SUBISSUE 4: HLW GLASS DEGRADATION AND RADIONUCLIDE RELEASE

**Appendix 7 Meeting: Container Life and Source Term
July 7-8, 1999, Lawrence Livermore National Laboratory, Livermore, CA**

NRC TPA3 SENSITIVITY ANALYSIS

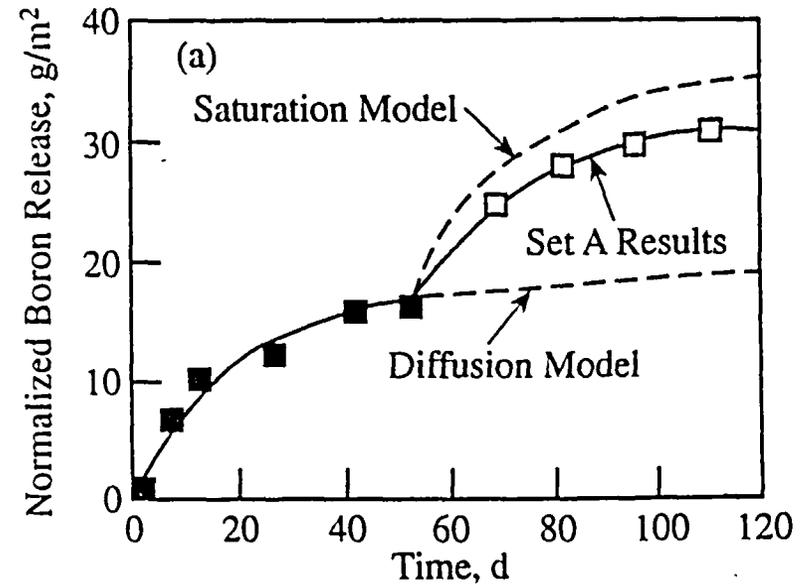
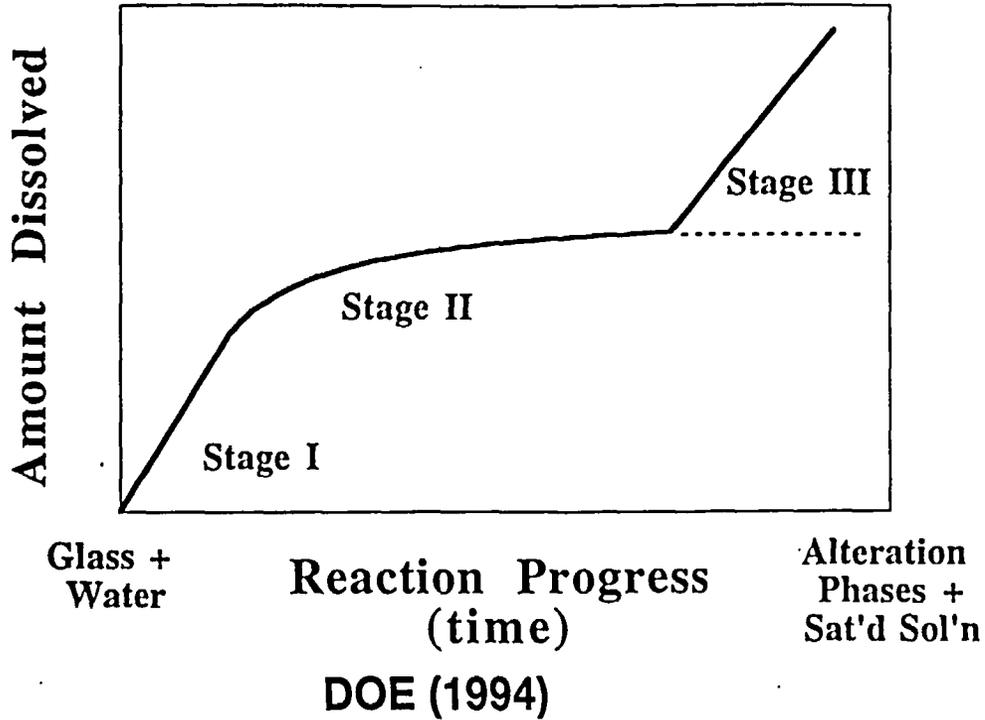
- **Using DOE's model from TSPA-VA to adjust input parameters for TPA3.2, 15% for 10,000 year and 5% for 50,000 year**

Ebert et al. (1998)

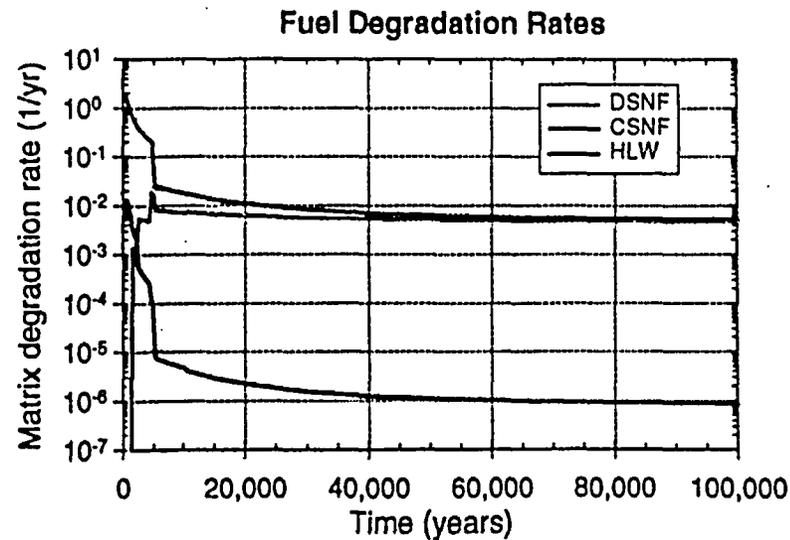
- Stage 3 dissolution rate: leach excursion because of the precipitation of secondary phase
